15/04236/LBC (CT.1571/N)

**Pigeon House
Church Road
Kemble
Gloucestershire
GL7 6AE**

External and internal alterations to facilitate conversion of barn to residential annexe at Pigeon House Church Road Kemble

Listed Building Consent 15/04236/LBC (CT.1571/N)	
Applicant:	Mr & Mrs Berry
Agent:	James Slater & Co
Case Officer:	Katherine Brommage
Ward Member(s):	Councillor Tony Berry
Committee Date:	13th January 2016

SURVEY OF BARN PLANS, SECTION AND ELEVATIONS

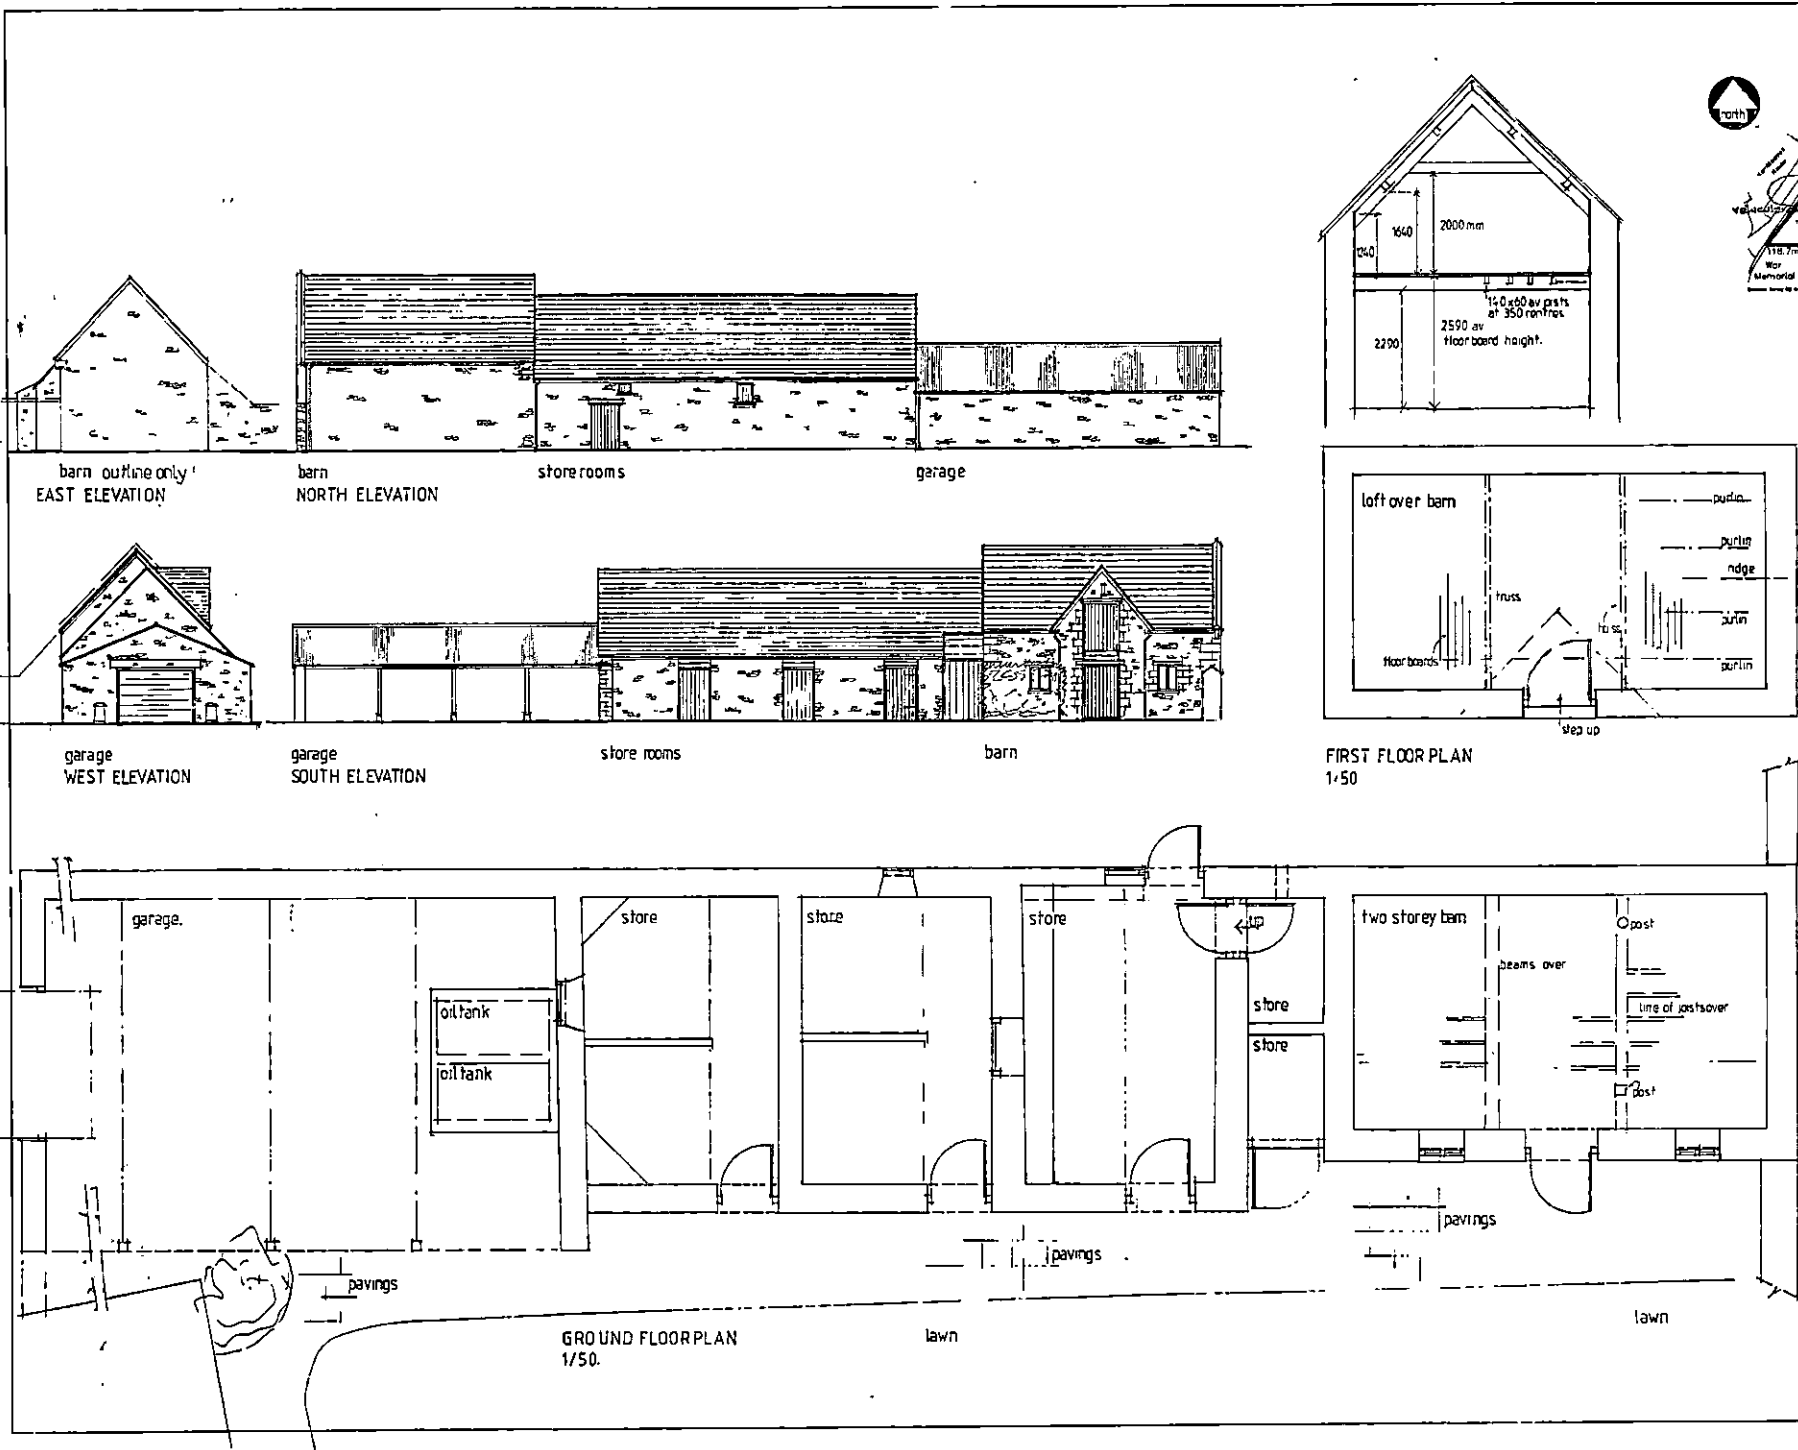
The building proposed (in part) for conversion is a former stable or cowshed with hayloft above. To its main south elevation two windows flank a central wide doorway. Directly above this is a similar doorway that provides the only current access to the hayloft. The roof is natural stone tile, with verge coping stones to its eastern end. There are two blind windows with moulded surrounds to the eastern gable. The moulded surrounds may have been reclaimed from elsewhere but likely included within this gable end to create a more attractive aspect towards the drive to Kemble Park. The rear, northern side, of the building is currently blank.

Scale: AS STATED
 Date: SEPT 2015
 Drawing Number: 14/124/02
 Rev: B

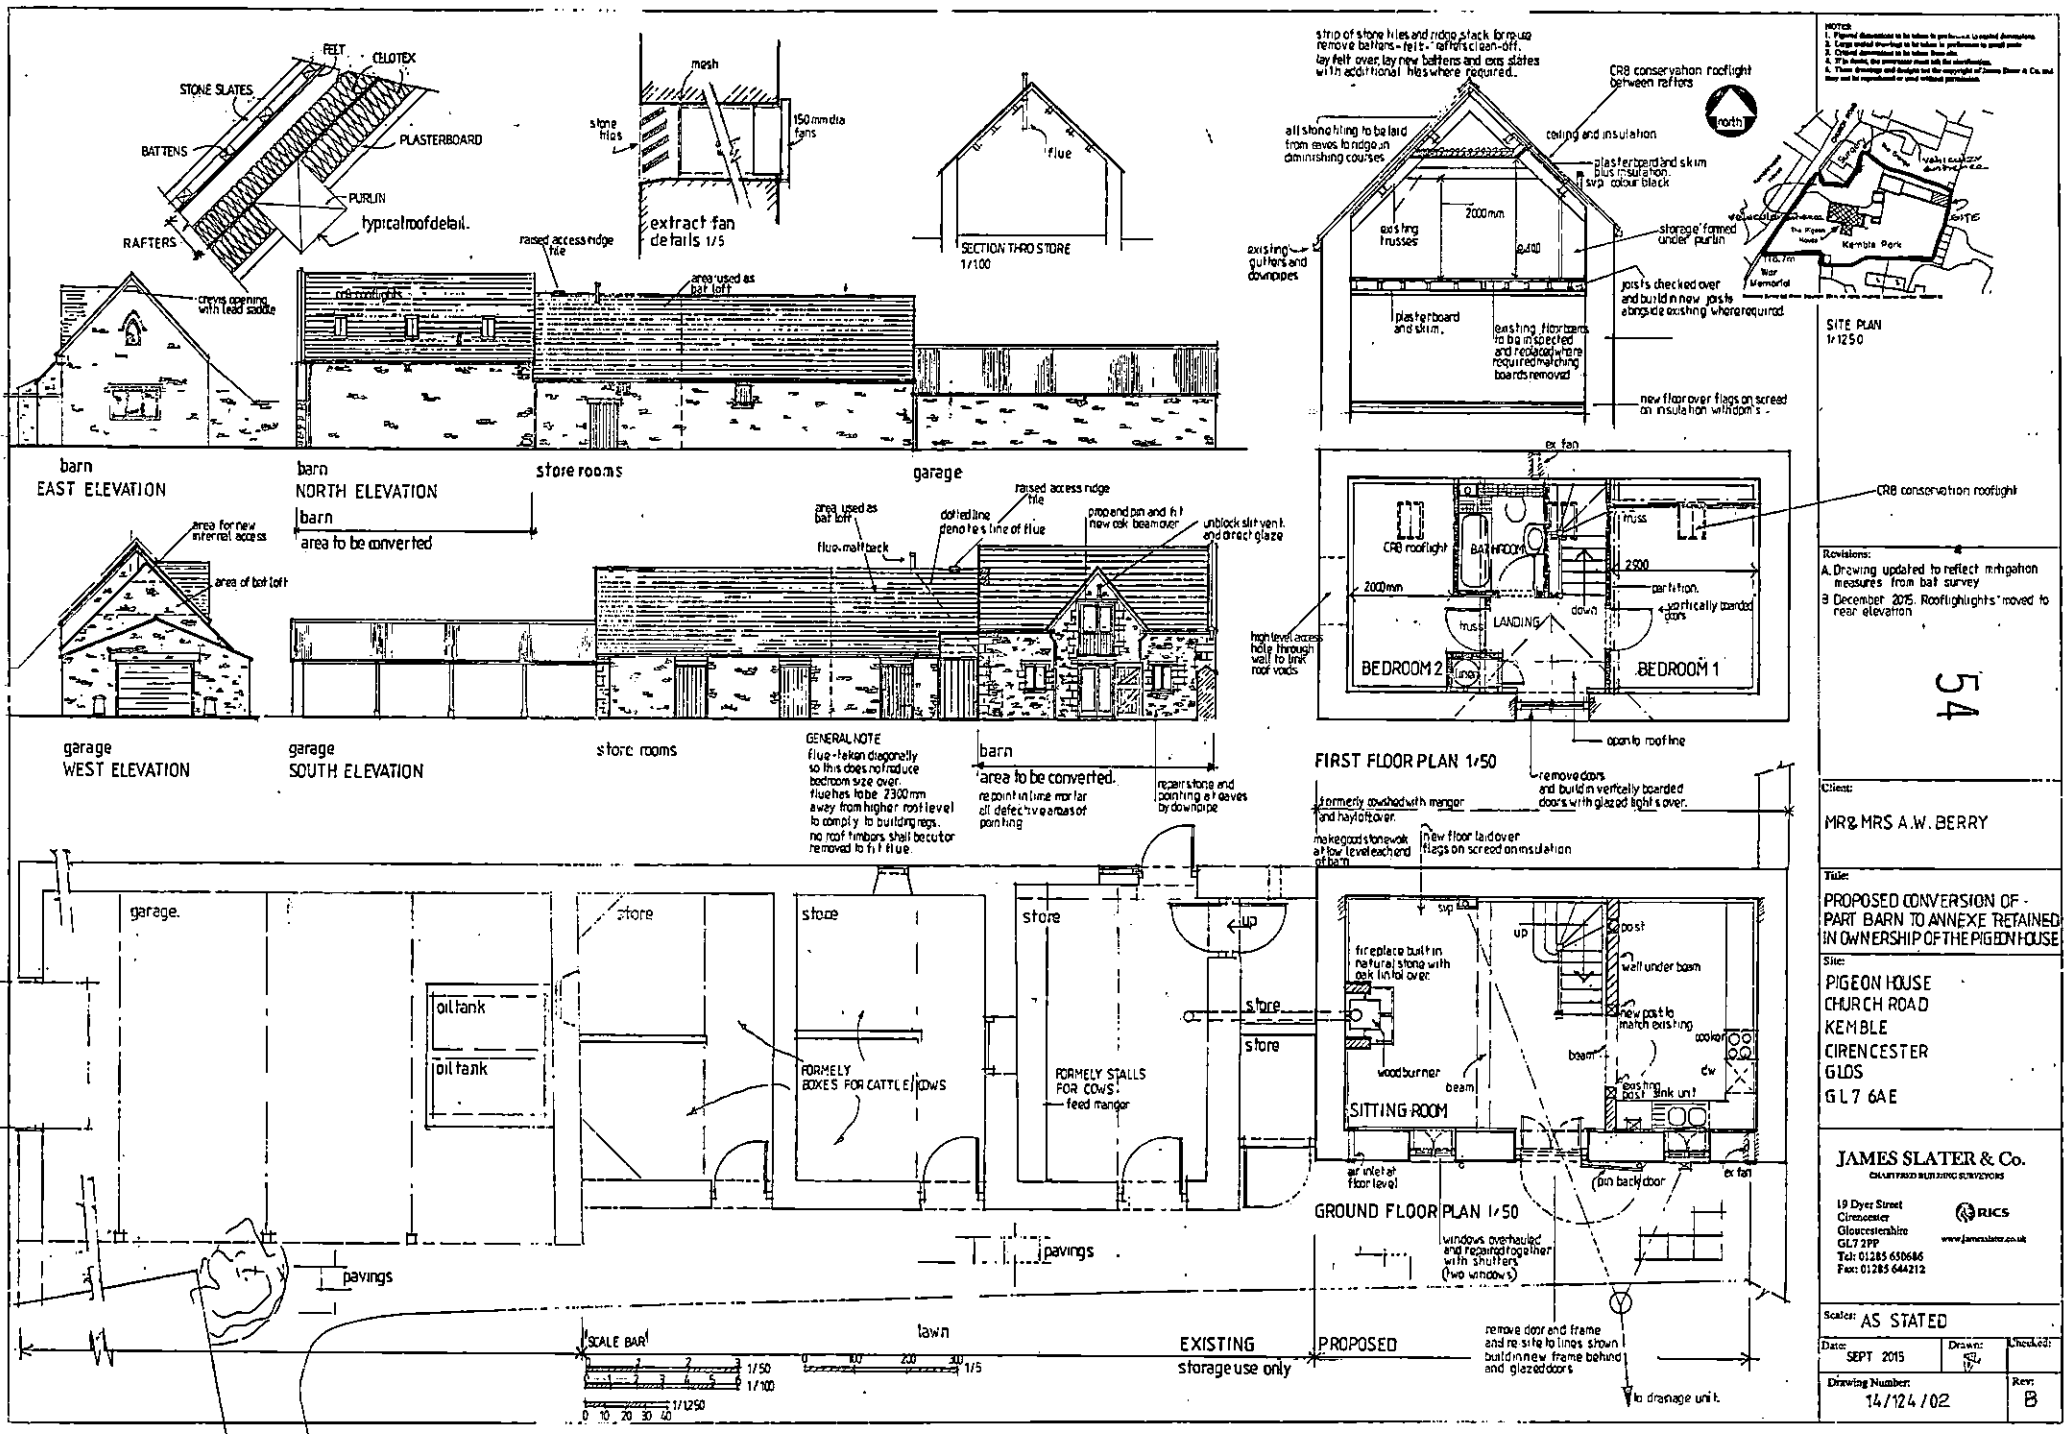
The building's upper floor is to include a bathroom to the rear and two bedrooms. On the original submitted plans the two bedrooms were shown to be lit by rooflights within the building's principal elevation. However, the Council's Conservation Officer considered this to be contentious, raising concerns that the proposed rooflights would substantially alter the southern principal elevation of the building, leading to visual crowding around the historic gable feature which would be harmful to the character of the building as it survives.

Amendments were therefore suggested by the Conservation Officer. It is recognised by officers that whilst the rear roof slope is currently unbroken, it is a lesser elevation. Further to the Conservation Officer's comments, amended plans have been submitted which specify three rooflights to the rear, one serving each of the proposed bedrooms and one serving the bathroom which is considered an improvement to that originally proposed and is acceptable on balance.

Internally, the design details of the proposed internal doors, staircase, fireplace, internal wall finishes and/or linings and retention of the historic trapdoor can all be conditioned. There remains concerns with regard to the internal stone fireplace specified on the amended plans since these are domestic features, incongruous to a historic agricultural building such as this (just as an external chimney would be). There are however, no objections to a wood burning stove, although this should be free-standing and not given any such permanent setting. Again, the design details can be controlled by condition (notwithstanding the submitted plans) and, on balance, would be acceptable.

The treatment of the internal walls is not clear. The floor plans indicate a lining treatment but the section does not. This should be clarified. Exposed stonework, perhaps with a lime washed finish is welcomed where practical, but if necessary a stud work lining (with adequate gap and ventilation for the masonry behind) would be accepted.

6. Notwithstanding the approved plans, prior to installation the design and details of the windows, doors, internal doors, staircase, fireplace, internal wall finishes or linings and retention of historic trapdoor shall be submitted to and approved in writing by the Local Planning Authority. The design and details shall be accompanied by drawings to a minimum scale of 1:5 with full size moulding cross section profiles, elevations and sections. The development shall only be carried out in accordance with the approved details and retained as such at all times.

7. The new rooflights shall be of a design which, when installed, shall not project forward of the roof slope in which the rooflight is located and shall be permanently retained as such thereafter.

Revisions:
 A. Drawing updated to reflect mitigation measures from bat survey
 B. December 2015. Rooflights moved to rear elevation
